Project	IEEE 802.16 Broadband Wireless Access Working Group < http://ieee802.org/16 >	
Title	Comment Resolution Details	
Date Submitted	2001-09-13	
Source(s)	Carl Eklund Nokia Research Center P.O.BOX 407 FIN-00045 Nokia Group, Finland	Voice: +348504836566 Fax:+358718036851 mailto:carl.eklund@nokia.com
Re:	IEEE Sponsor Ballot of IEEE P802.16/D4-2001	
Abstract	Adds specific detail to comment resolutions	
Purpose	For use in conjunction with comment resolution database	
Notice	This document has been prepared to assist IEEE 802.16. It is offered as a basis for discussion and is not binding on the contributing individual(s) or organization(s). The material in this document is subject to change in form and content after further study. The contributor(s) reserve(s) the right to add, amend or withdraw material contained herein.	
Release	The contributor grants a free, irrevocable license to the IEEE to incorporate material contained in this contribution, and any modifications thereof, in the creation of an IEEE Standards publication; to copyright in the IEEE's name any IEEE Standards publication even though it may include portions of this contribution; and at the IEEE's sole discretion to pe

Figure 1 – SS Initialization Overview

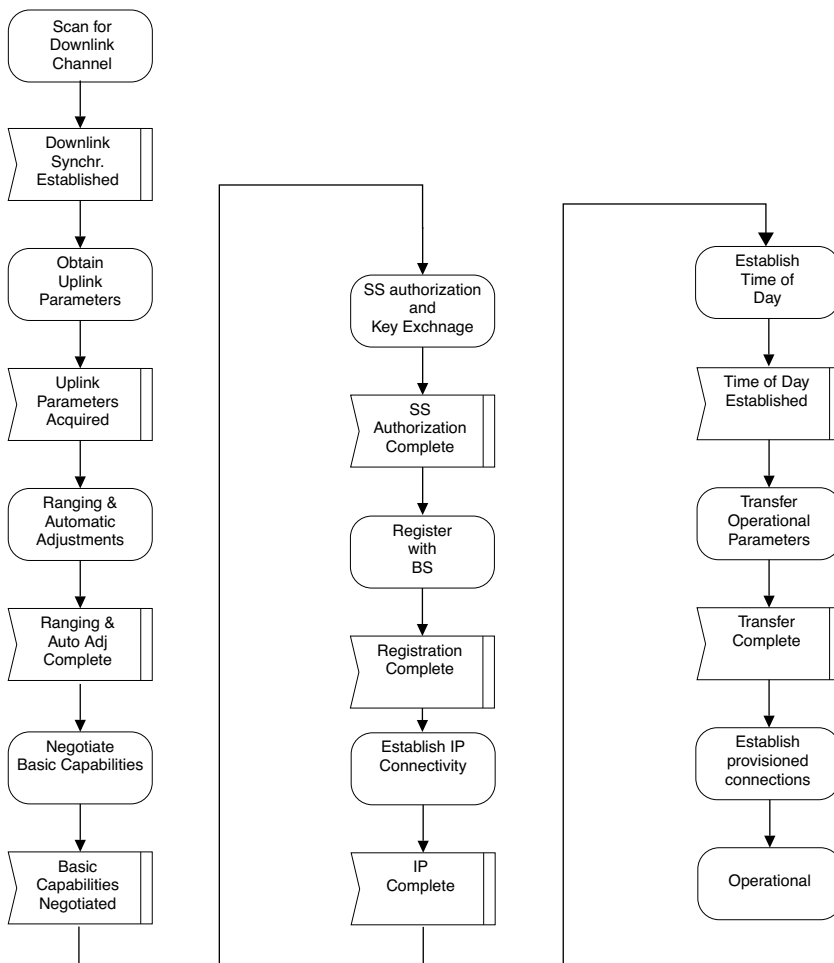
Comment: Replace Figure 45 on page 132 with Figure 1 below. Rationale: Figure 45 is incorrect

Figure 4— Maintaining Downlink Synchronization

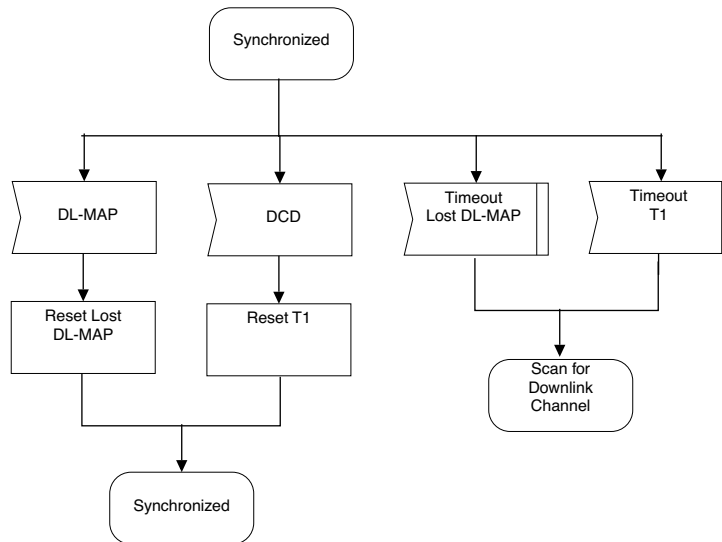
Comment: Insert figures 2 and 4 into section 6.2.9.2. on page 132. Rationale: The figures clarify the text

Figure 5— Obtaining Uplink Parameters

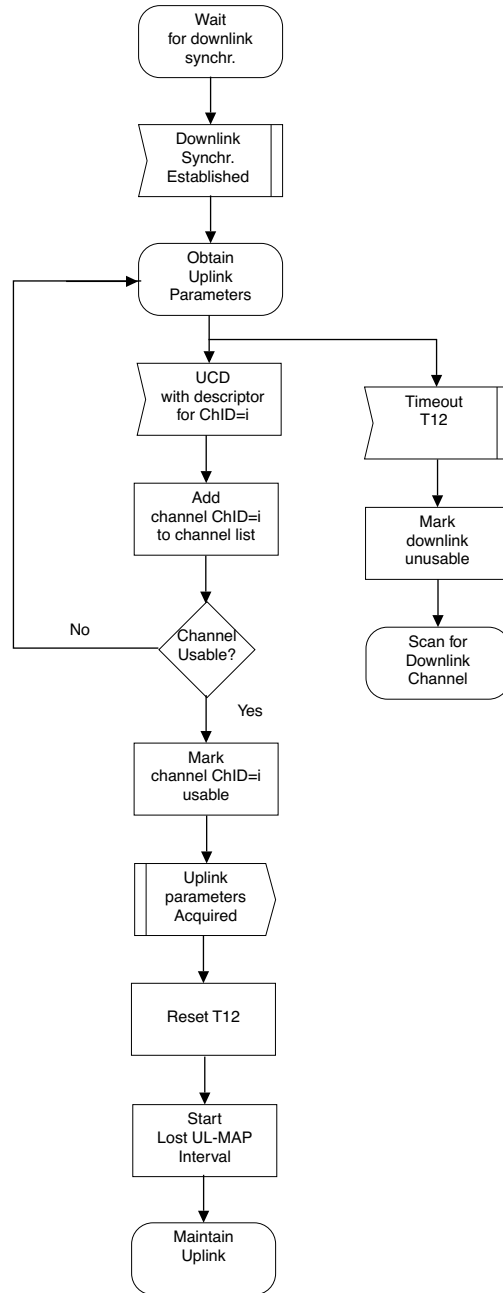
Comment: Insert figures 5 and 6 of this document into section 6.2.9.3 Rationale: The figures clarify the text

Figure 7— Multicast Polling Assignment, SS

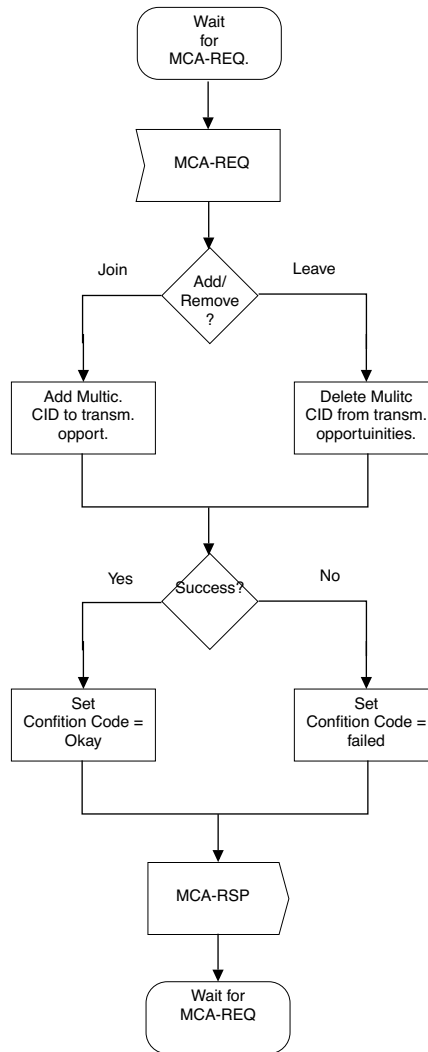
Comment:Create new section H3 between 6.2.12 and 6.2.13 on page 151 with the heading “Assigning SSs to multicast groups”The content of the section: “ The BS may add an SS to a Multicast polling group by sending a MCA-REQ message with the Join command. Upon receiving a MCA-REQ the SS shall respond by

1 sending a MCA-RSP. The protocol is shown in Figure 7 and Figure 8. “ Add the corresponding figures to this
 2
 3
 4
 5
 6
 7
 8
 9
 10
 11
 12
 13
 14
 15
 16
 17
 18
 19
 20
 21
 22
 23
 24
 25
 26
 27
 28
 29
 30
 31
 32
 33
 34
 35
 36
 37
 38
 39
 40
 41
 42
 43
 44
 45
 46
 47
 48
 49
 50
 51
 52
 53
 54
 55
 56
 57
 58
 59
 60
 61
 62
 63
 64
 65
